SERVICE BULLETIN M20-240
DATE: 1 - 13 - 89

SUBJECT: MOONEY AIRCRAFT CORPORATION, M20L MASTER SWITCH CIRCUIT MODIFICATION.

MODEL/S/N AFFECTED: MOONEY M20L, S/N 26-0001 THRU 26-0045

FIGURE M20-240-1

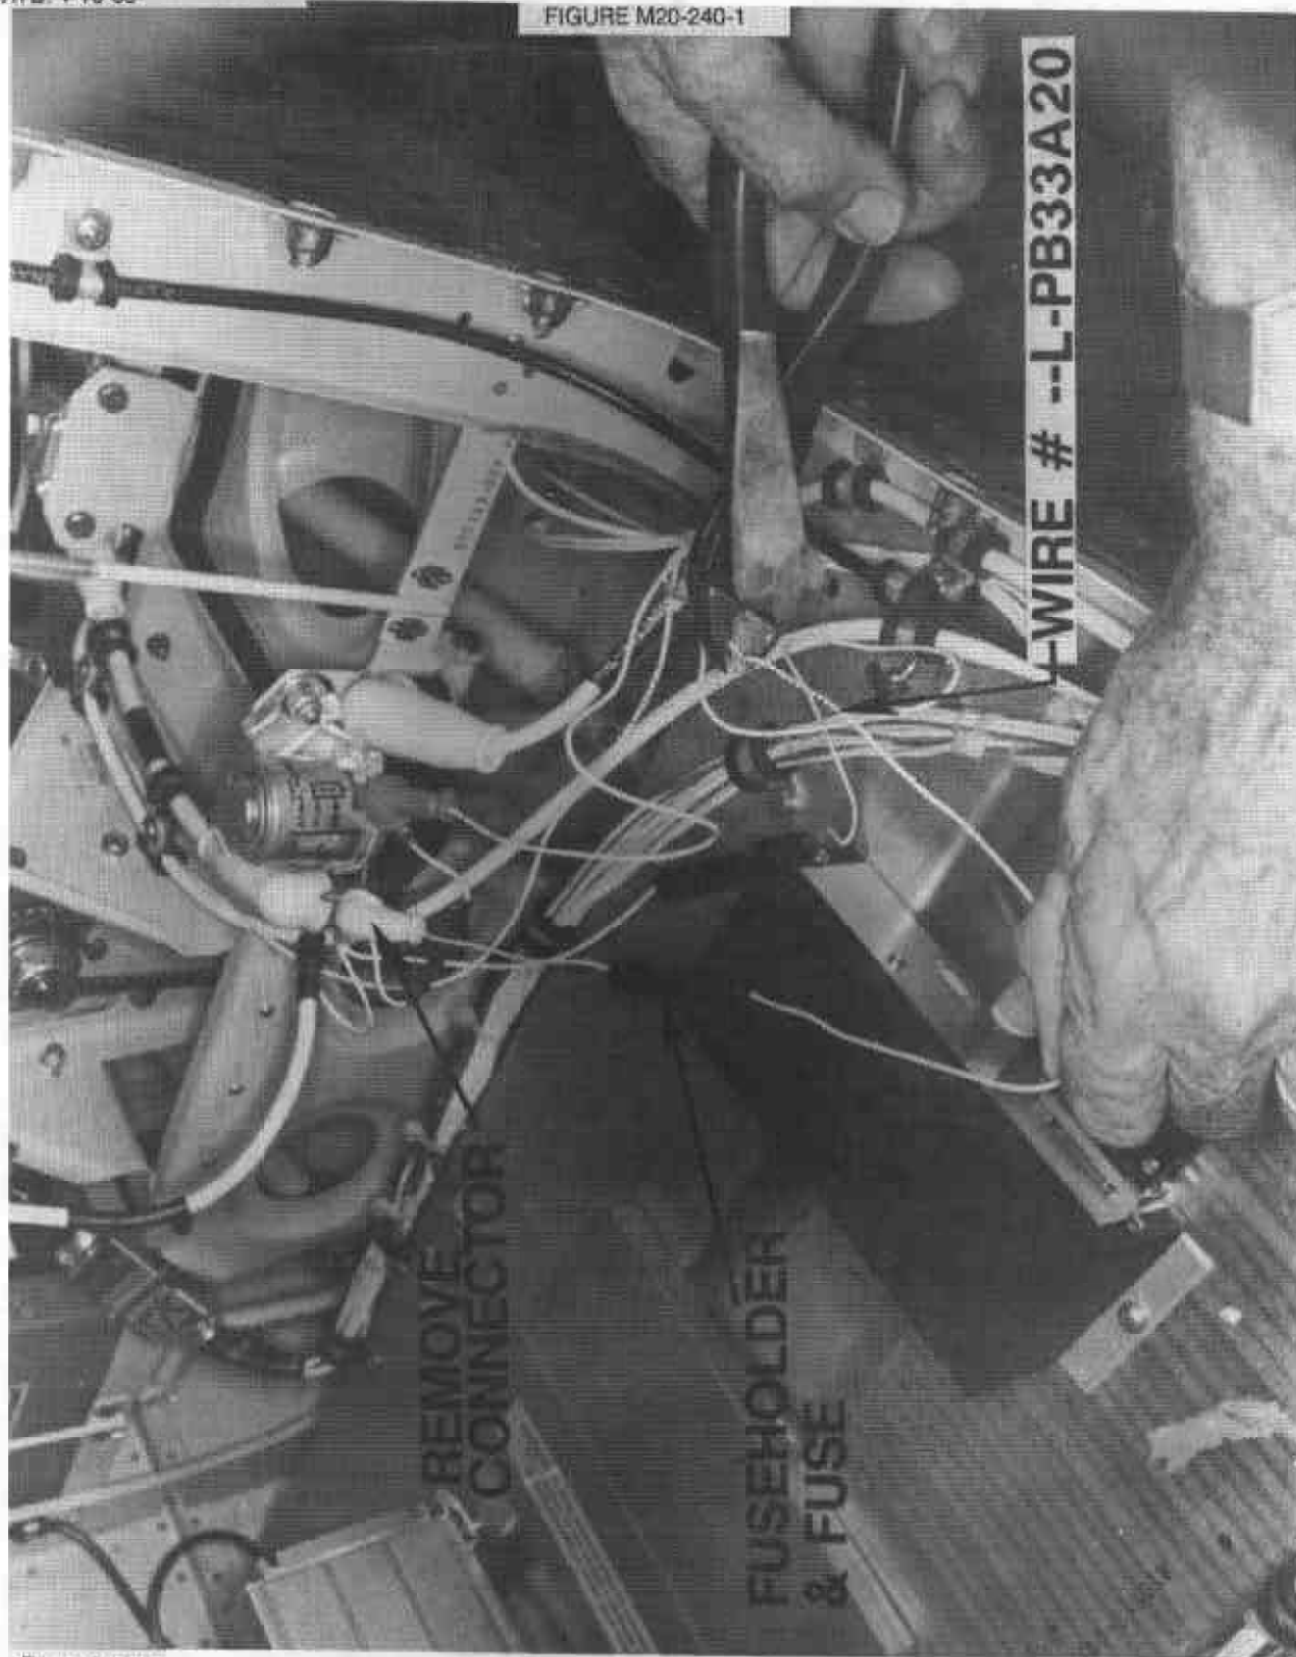
1. Remove left rear tailcone access door and perform the following actions:
(SEE FIGURE NO. 1 BELOW)
 - a. Remove wire (—L-PB33A20) from tailcone connector (JKL-PL20A), pin 1, by clipping wire approximately 1.5 inches from connector and install a wire cap on the portion still connected to the connector.

- b. Remove wire (—L-PB32A20) ring terminal from left battery relay, pin X.
 - c. Remove this separated wire, which includes the Left Master Fuseholder (L-PB180A) and fuse, from the tailcone and discard.

FIGURE M20-240-3

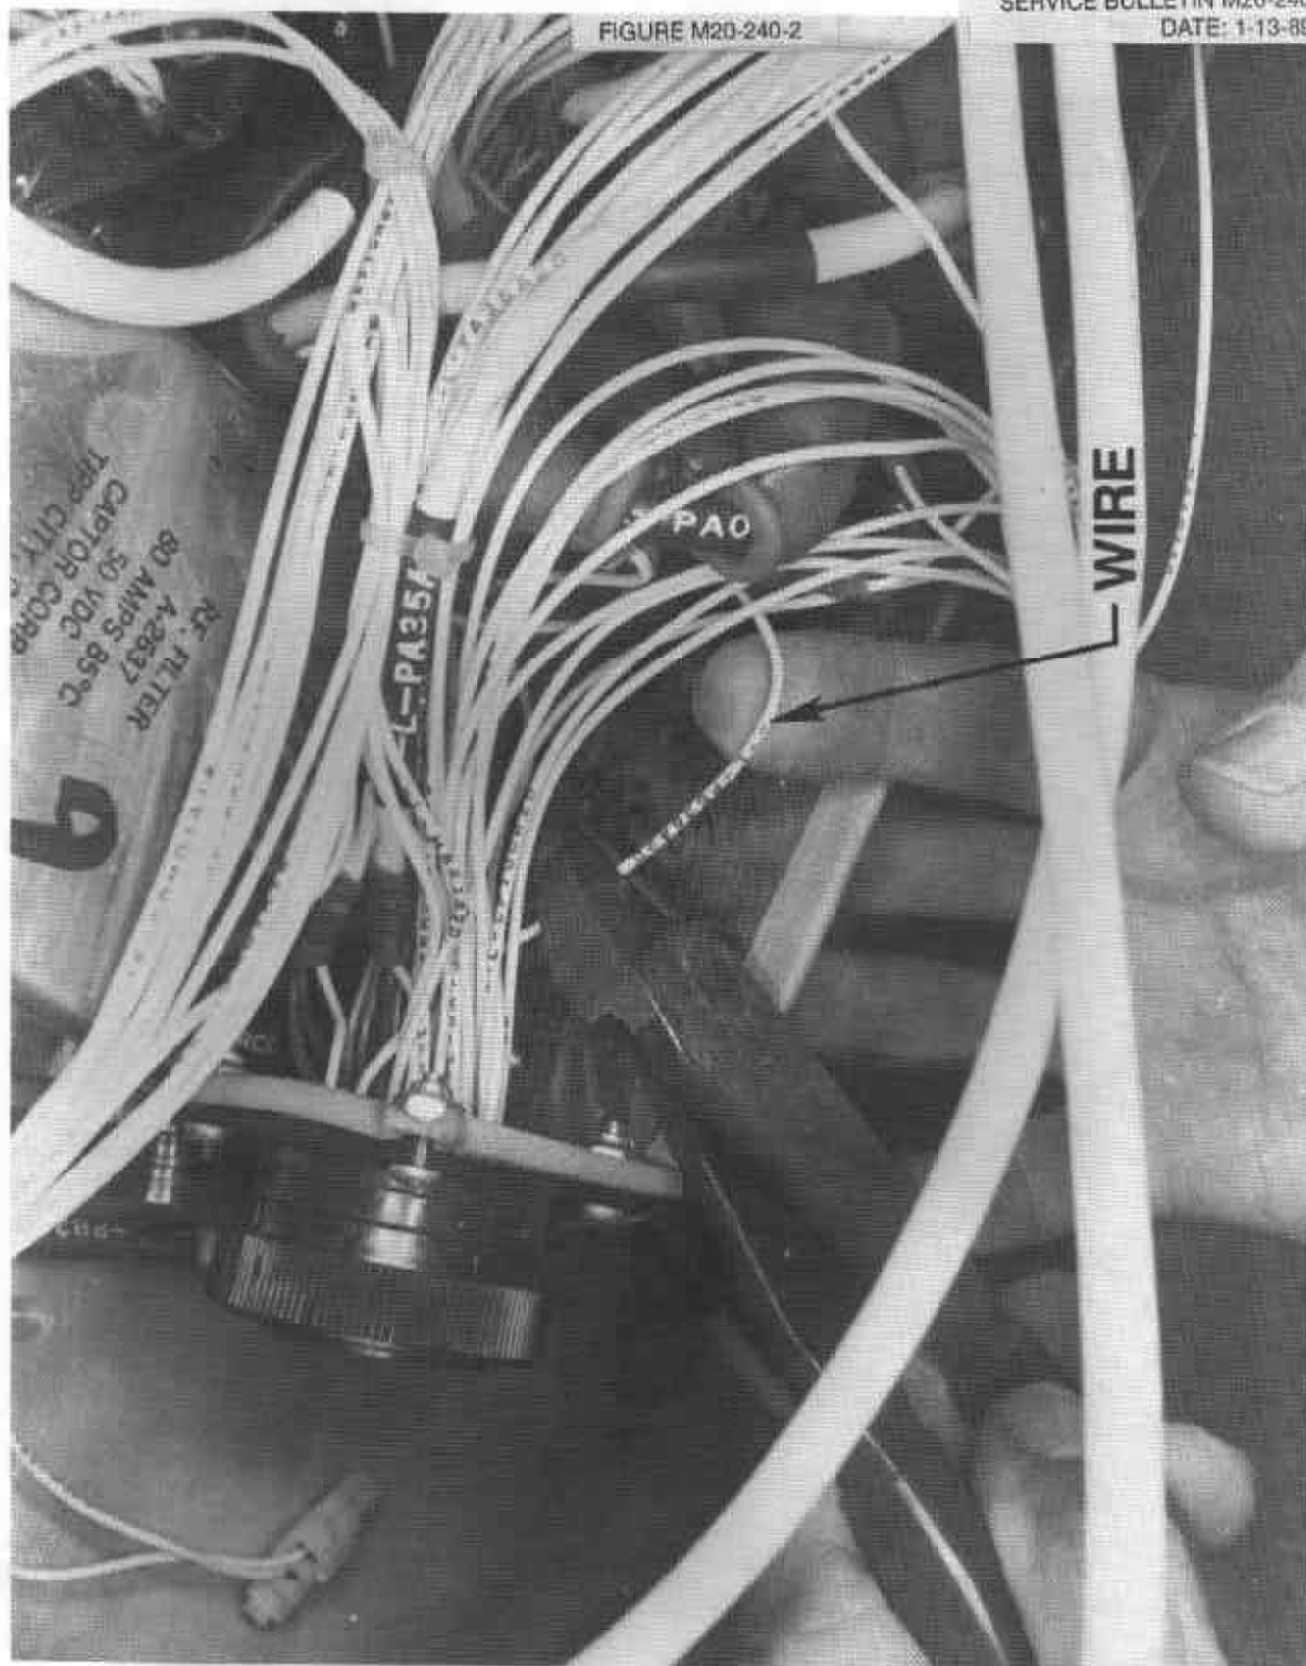
5. Cut wire (—L-PB36A20) at pin # 20 of circuit breaker panel connector No. 2 (JKL-PL50A) by clipping wire approximately 1.0 inches from connector (SEE FIGURE NO. 2). and installing wire cap, P/N 324485, on end of wire still connected to the connector (SEE FIGURE NO. 3).

FIGURE M20-240-4

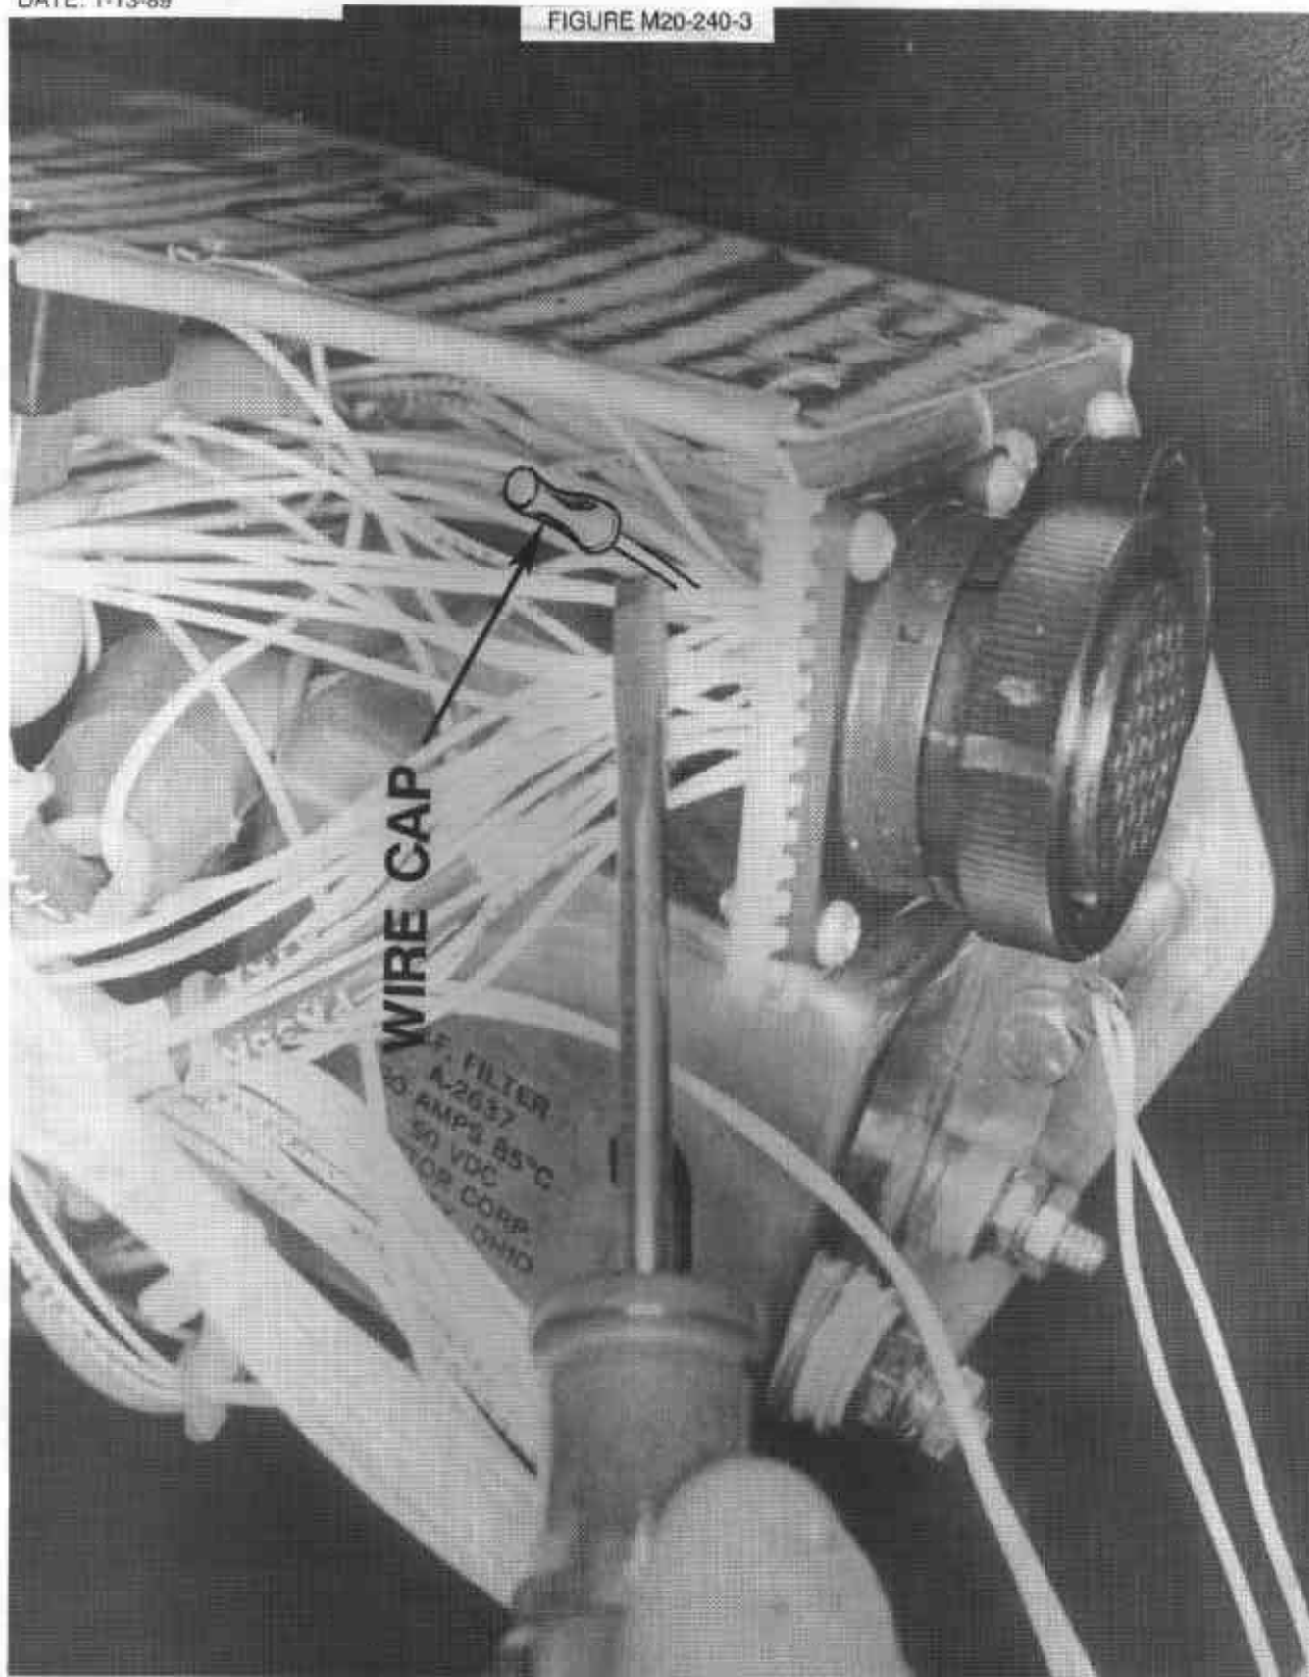
6. Strip and install AMP ring terminal P/N 31894, (Blue color) to the end of the wire disconnected from the No. 2 connector.
7. Attach this ring terminal to the buss side of "Left Load" circuit breaker (—L-PB171A) (SEE FIGURE NO. 4).
